APPLICATION NO.	FILING DATE	FIRST NAMED INVENTOR	ATTORNEY DOCKET NO.	CONFIRMATION NO.
10/724,299	11/26/2003	Raffi Codilian	K35A1398	1174
35219 7590 07/12/2007 WESTERN DIGITAL TECHNOLOGIES, INC. ATTN: RENEE FRANKS 20511 LAKE FOREST DR. E-118H LAKE FOREST, CA 92630			EXAMINER SEMENENKO, YURIY	
			ART UNIT 2841	PAPER NUMBER
			MAIL DATE 07/12/2007	DELIVERY MODE PAPER

Office Action Summary	Application No. 10/724,299	Applicant(s) CODILIAN, RAFFI	
	Examiner Yuriy Semenenko	Art Unit 2841

DETAILED ACTION

Fig. 1*

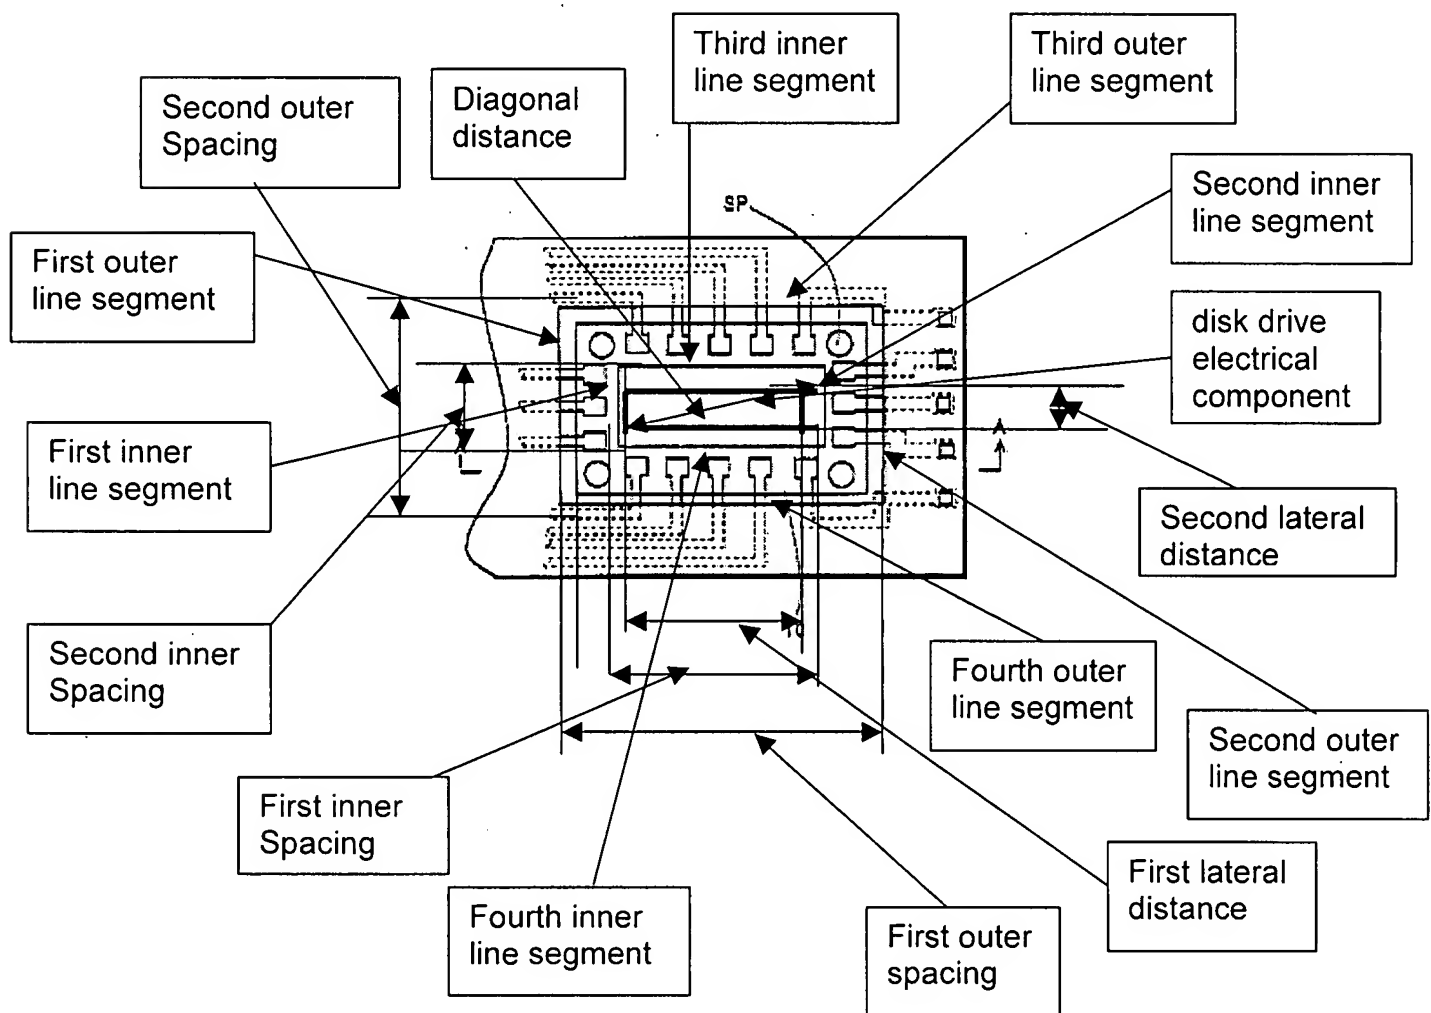
As to claim 1: Sakamoto discloses in Fig. 1 a disk drive printed circuit board 11 (page 7, [0114]) for use with a disk drive electrical component 16, Fig. 1A and Fig. 1* below, the disk drive electrical component 16, defining a rectangular perimeter, Fig. 1A, the perimeter including opposing first and second edges spaced apart a first lateral distance (see Fig. 1*, below), the perimeter further including opposing third and fourth edges extending between the first and second edges and spaced apart a second lateral distance, Fig. 1*, the perimeter further including opposing corners spaced apart a diagonal distance, (see Fig. 1*), the printed circuit board comprising: a board body 11, Fig. 1 (page 7, [0114]); a mounting surface disposed upon the board body; and component-dedicated alignment line indicators disposed at the mounting surface for visibly aligning the disk drive electrical component at the mounting surface (intended use) (component-dedicated alignment line indicators includes portions of the surface of the first and second insulating sheets P1 and P2, Fig. 2 (see also Fig. 2*, below)); the component-dedicated alignment line indicators including: first and second inner line segments (this two segments define the second opening portion 13, Fig. 1 (page 9,

[0139]) spaced apart a first inner spacing at least the first lateral distance and less than the diagonal distance (see Fig. 1*, below); third and fourth inner line segments extending between and perpendicular to the first and second inner line segments (this two segments define the second opening portion 13, Fig. 1 is formed in the first insulating sheet P1 (page 9, [0139]), the third and fourth inner line segments spaced apart a second inner spacing at least the second lateral distance and less than the diagonal distance (Fig. 1*); and first and second outer line segments (this two segments define the first opening portion OP, Fig. 1 is formed in the second insulating sheet P2 (page 9, [0140]), the second opening portion 13, Fig. 1 disposed parallel to the first and second inner line segments with the first and second inner line segments between the first and second outer line segments, the first and second outer line segments spaced apart a first outer spacing more than the first inner spacing and less than the diagonal distance, Fig. 1*.

As to claim 2: Sakamoto, as modified, discloses the printed circuit board having all of the claimed features as discussed above with respect claim 1, wherein the third and fourth inner line segments intersect the first-and second inner line segments (Fig. 1*).

As to claim 3: Sakamoto, as modified, discloses the printed circuit board having all of the claimed features as discussed above with respect claim 1, wherein the component-dedicated alignment line indicators (Fig. 1*) further includes a third outer line segment extending between and perpendicular to the first and second outer line segments, the third outer line segment is disposed with the third inner line segment between the third edge of the disk drive component and the third outer line segment, Fig. 1*.

As to claim 4: Sakamoto, as modified, discloses the printed circuit board having all of the claimed features as discussed above with respect claim 3, wherein the third outer line segment intersects the first and second outer line segments, Fig. 1*.

As to claims 5 and 6: Sakamoto, as modified, discloses the printed circuit board having all of the claimed features as discussed above with respect claim 1, wherein the component-dedicated alignment line indicators further includes third and fourth outer line segments extending between and perpendicular to the first and second outer line segments, the third and fourth inner line segments spaced apart a second outer spacing at least the second lateral distance and less than the diagonal distance, Fig. 1*, and wherein the third outer line segments intersect the first and second outer line segments, Fig. 1*.

As to claim 17: Sakamoto, as modified, discloses the printed circuit board having all of the claimed features as discussed above with respect claim 16, further comprising an addition pair of outer line segments (third outer line segment and four outer line segment, Fig. 1*) disposed parallel to and spaced apart from the second pair of the inner line segments (third inner line segment and four inner line segment, Fig. 1*), with the second pair of the inner line segments being positioned between the additional pair of outer line segments.

As to claim 18: Sakamoto, as modified, discloses the printed circuit board having all of the claimed features as discussed above with respect claim 17 wherein the inner line segments and the outer line segments are visibly disposed on the mounting surface (Fig. 1*).

Fig.2*

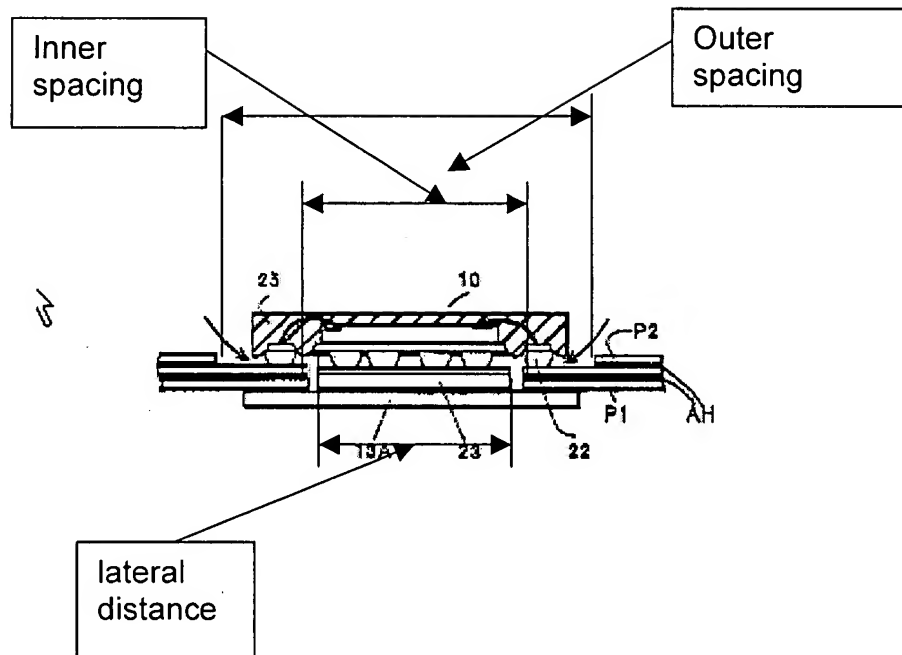
Eleventh Edition, page 1257). Mounting surface is a surface used for mounting on it any parts of the assembly. Hence, mounting surface of the board body 11, Fig. 1 (Sakamoto) completely satisfied to this definition (please see Fig. 2 B and C). Next, any edges can be consider as a visual reference or "line indicators" (in using of the applicant's language). Further in opposite to the Applicant's statement " With reference to Sakamoto at Figures 1A and 1B, the edges of a radiation substrate 13A that is mounted on the opposite side as the electric component 10 are cited by the Examiner as showing the outer line segments", the Examiner never use a radiation substrate 13A in the rejections (see all of the Office Actions and especially Fig. 1*, below).
